EO 55-45-6A

5 Jun 69

LIST OF FIELD MODIFICATIONS
SAFETY HARNESS - GENERAL

Figure 1

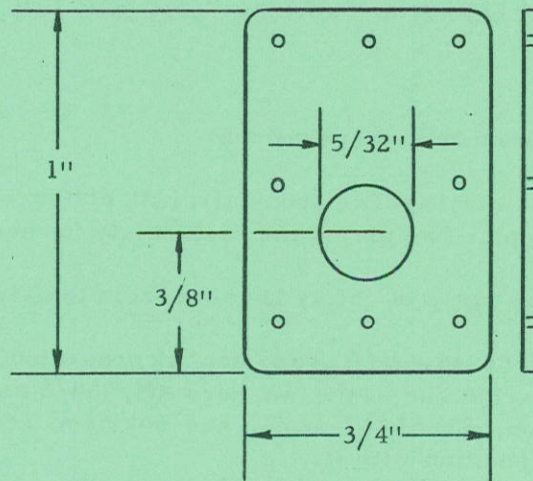
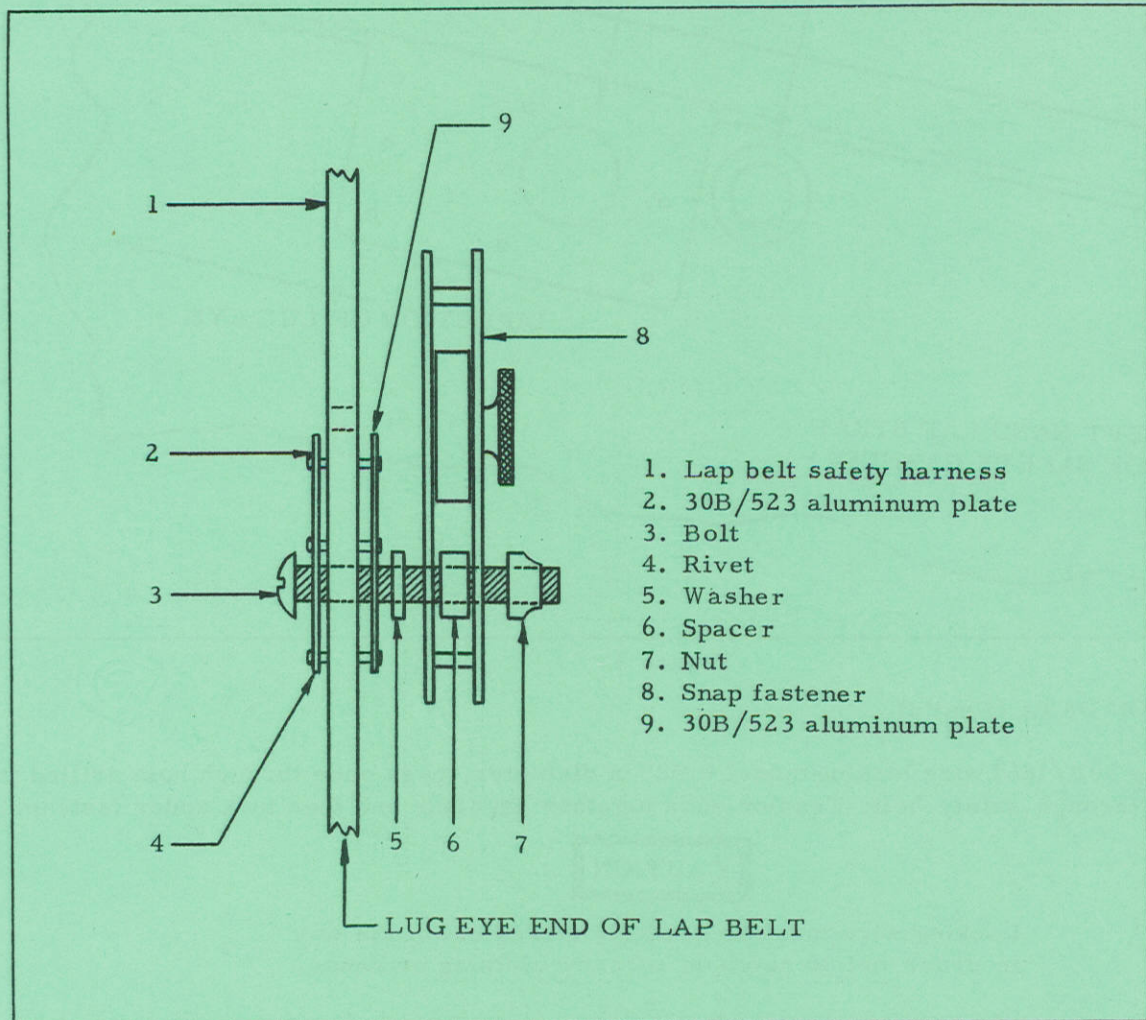
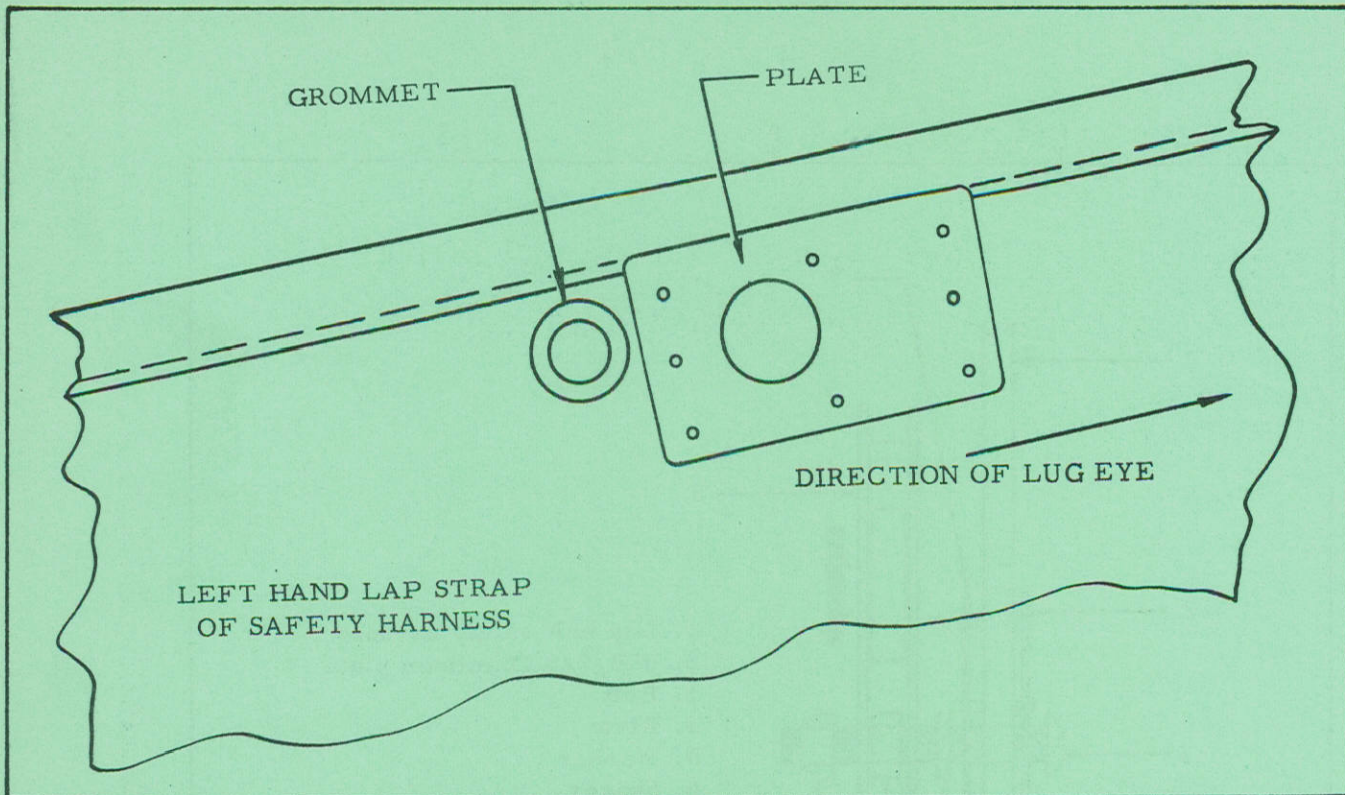
- (a) Before removing safety harness from aircraft plates as per Figure 1 are to be manufactured by station workshops. Two plates for each safety harness are required.

- (d) The brass grommet closest to left hand lap strap lug is to be carefully removed. Plates manufactured as per Figure 1 are to be riveted in position on lap belt as per Figure 3. Copper or aluminum rivets 1/16" in diameter are to be used for this. Slightly larger rivets may be used depending on availability of stocks, however round head style only is to be used. Care must be taken that 5/32" holes in plates line up with hole where grommet was removed. When riveting plates, a snug fit to safety harness must be obtained and any excess length of rivet is to be cut off before peening so that only enough to securely hold plated together is left for peening.

- (e) Attach snap fastener to lap belt in sequence as illustrated by Figure 2.
- (f) Method of further securing snap fastener in position as outlined in EO 55-45-6A/7, para. (e), page 5, and Figure 5, page 4, is to be changed as follows:-

Figure 1

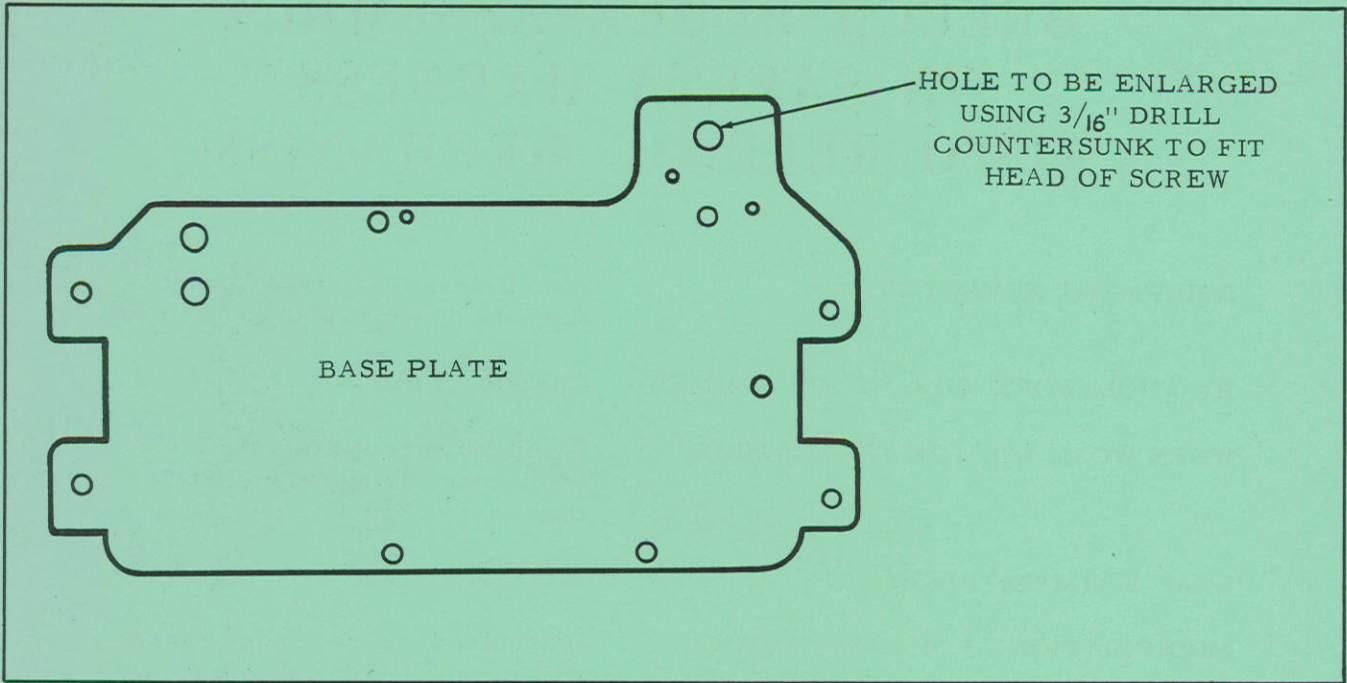
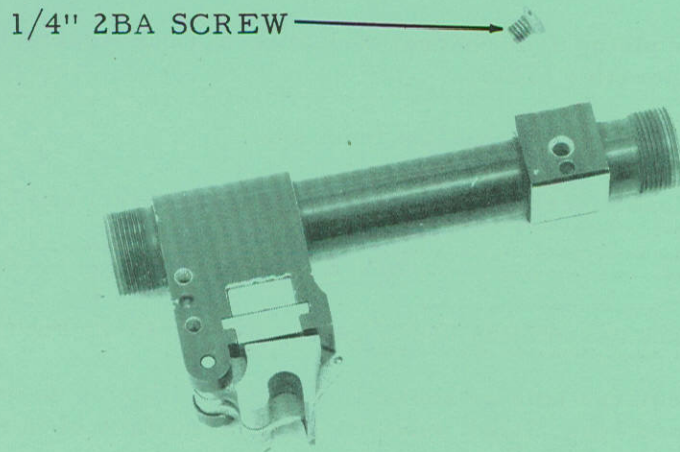
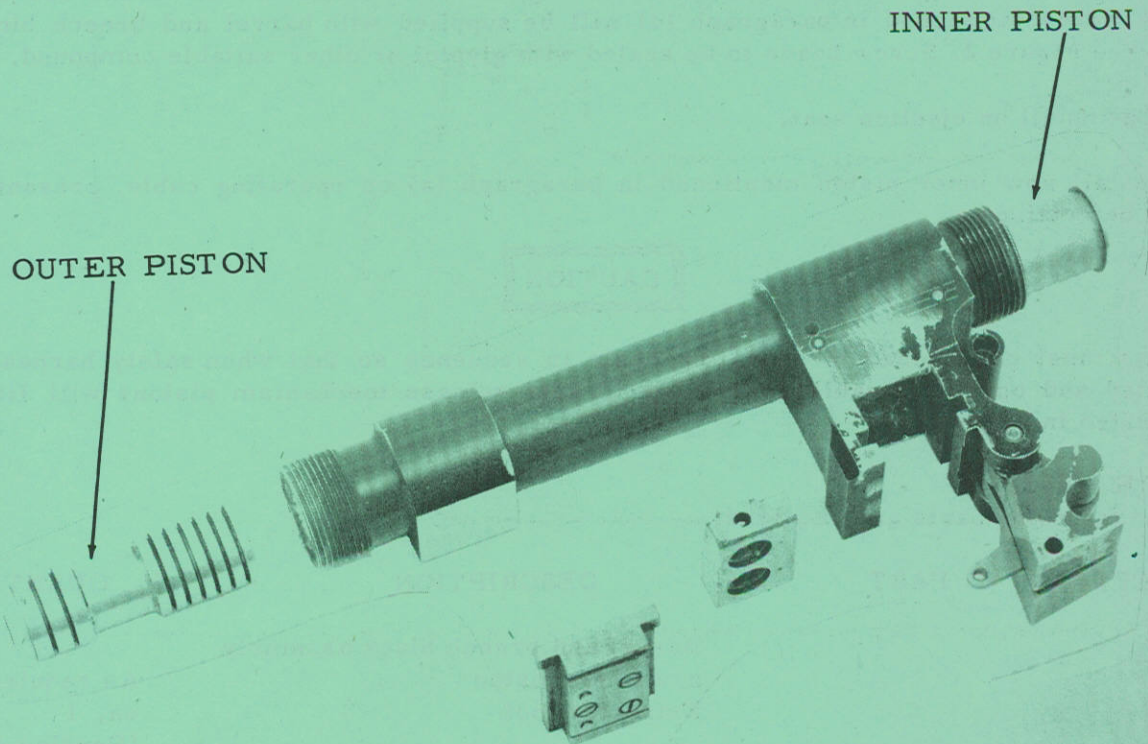
- (d) Using 3/16" drill enlarge hole as shown in Figure 1. Hole is to be countersunk to fit the chamfer of 1/4" 2BA screw head. Head must fit flush to surface of base plate when tightened.

- (e) Re-assemble auto release mechanism using new barrel and breech block. One-quarter inch 2BA screw mentioned in paragraph (d) will be supplied with barrel and breech block assembly, see Figure 2. Screw heads to be sealed with glyptol or other suitable compound.
- (f) Re-install on ejection seat.
- (g) Install new inner piston mentioned in paragraph (a) on operating cable, present outer piston to be retained.

Pistons must be attached to operating cable in sequence so that when safety harness is installed and operating cable assembled to auto release mechanism pistons will fit as illustrated in Figure 3.

Figure 1

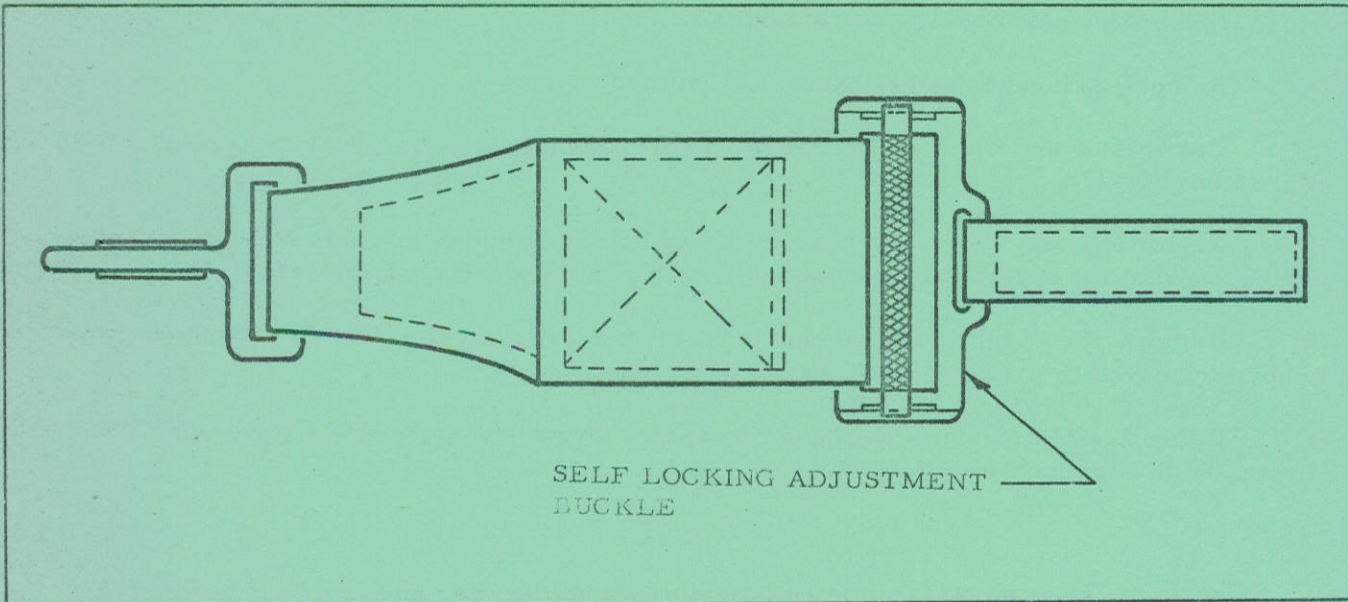
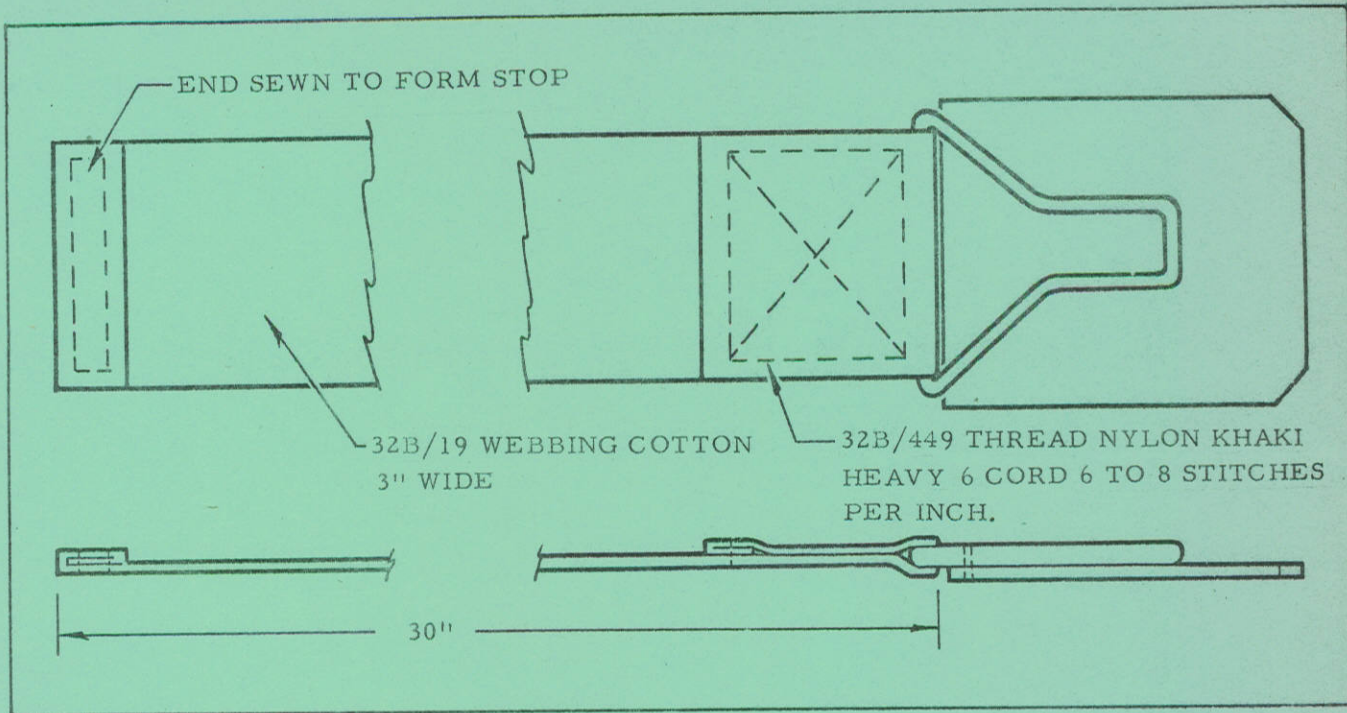
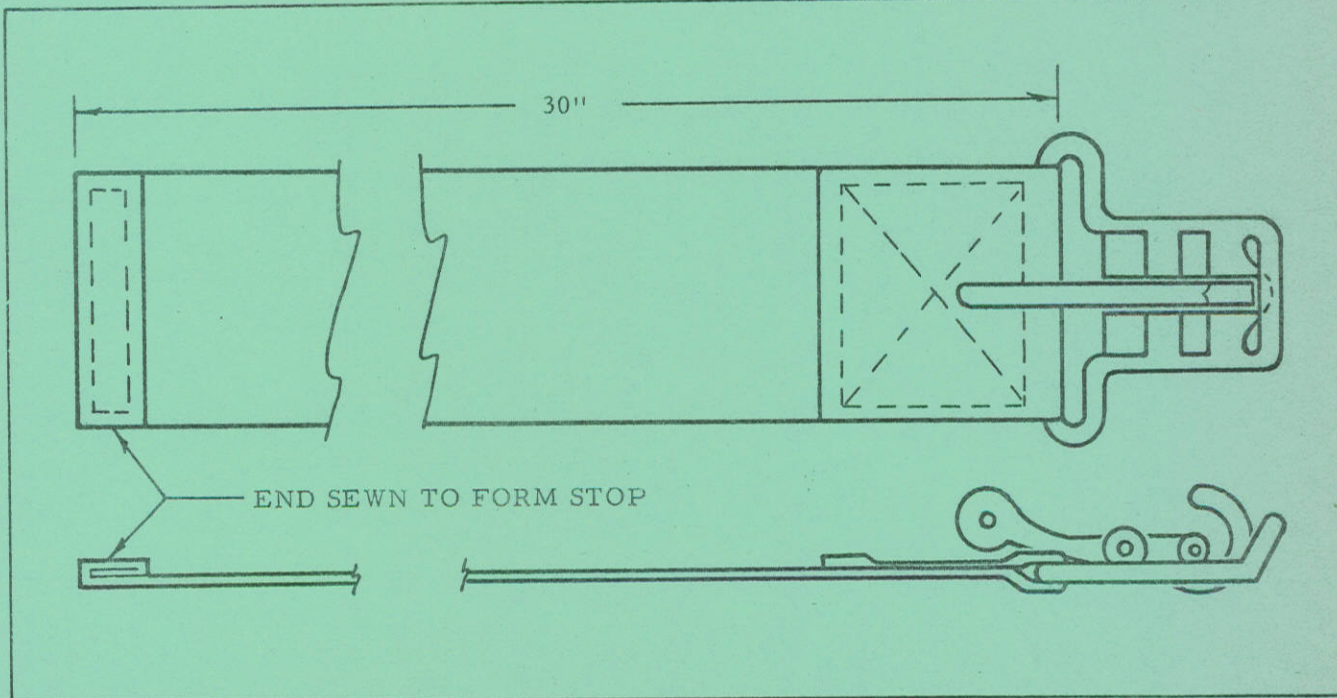
- (a) Remove passenger safety harness from aircraft.
- (b) Cut thread and open up end stop so that webbing may be separated from self-locking adjustment buckles.
- (c) Retain left and right hand portion of lap belt comprising aircraft attachment snap, self-locking adjustment buckle, and connecting webbing in its original state, see Figure 1.
- (d) Remove lever type locking buckle and lever type locking buckle attachment lug from webbing removed in paragraph (b). Discard webbing.
- (e) Using 32B/19 webbing cotton 3" wide and thread nylon 32B/449 make up new belts as illustrated in Figures 2 and 3.

Figure 1

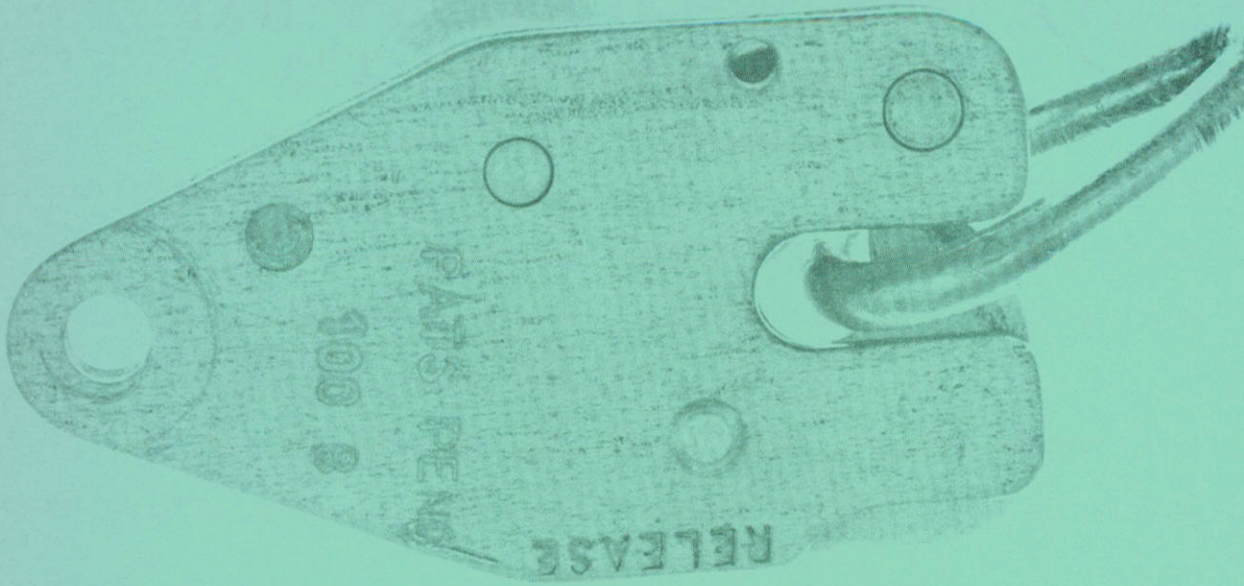
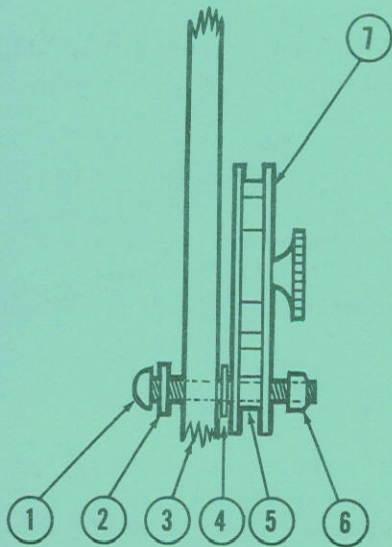
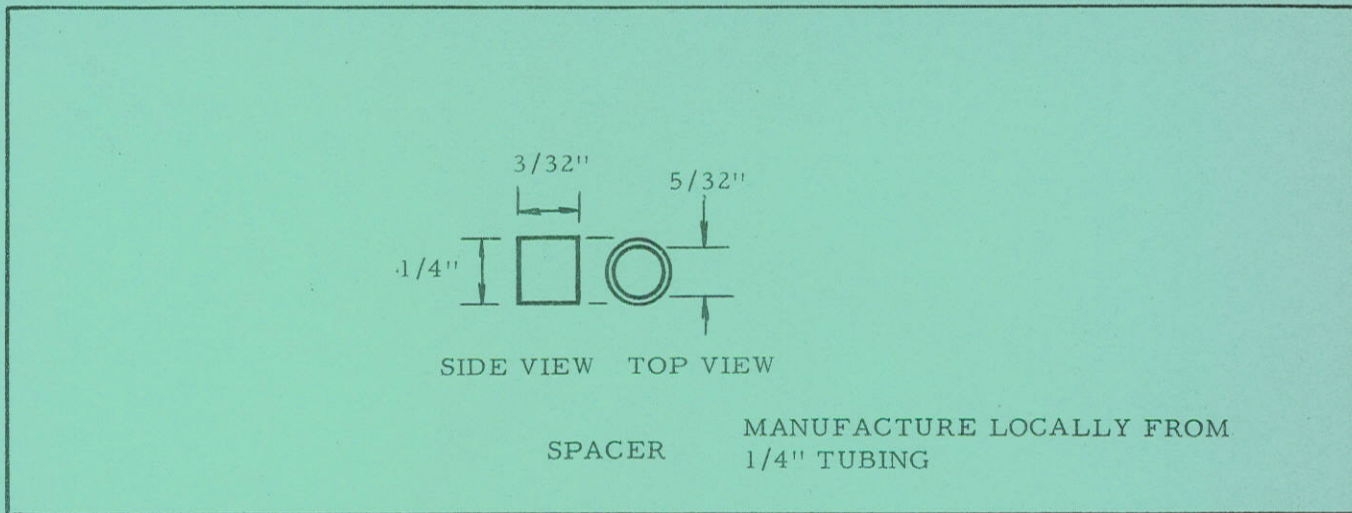
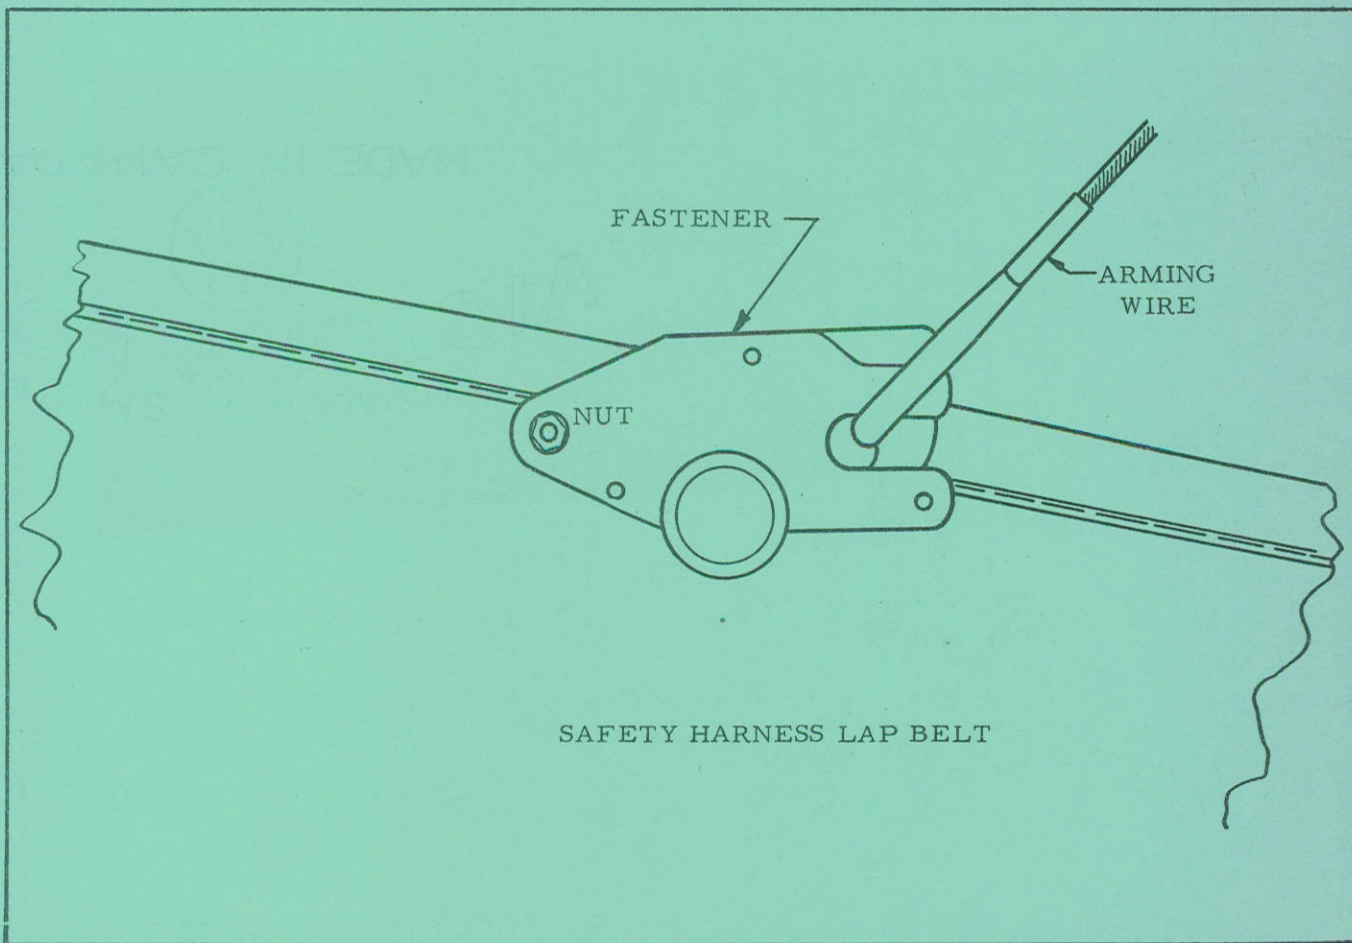
- (a) Remove present snap hook from harness and discard hook, screw, washer and nut.
- (b) Drill a hole through the underside of the new snap fastener using a 3/32" drill as shown in Figure 1. This hole will be used after fastener is attached to safety belt to further secure fastener in position.

(c) Attach snap fastener 15E/63 to LH lap strap in sequence outlined in Figure 2. The brass grommet closest to LH lap strap lug is to be used for this connection.

Spacer is to be manufactured locally from 1/4" dural tubing as per Figure 3.

(d) Care must be taken that the snap fastener is positioned as indicated by Figure 4 when nut is securely tightened.
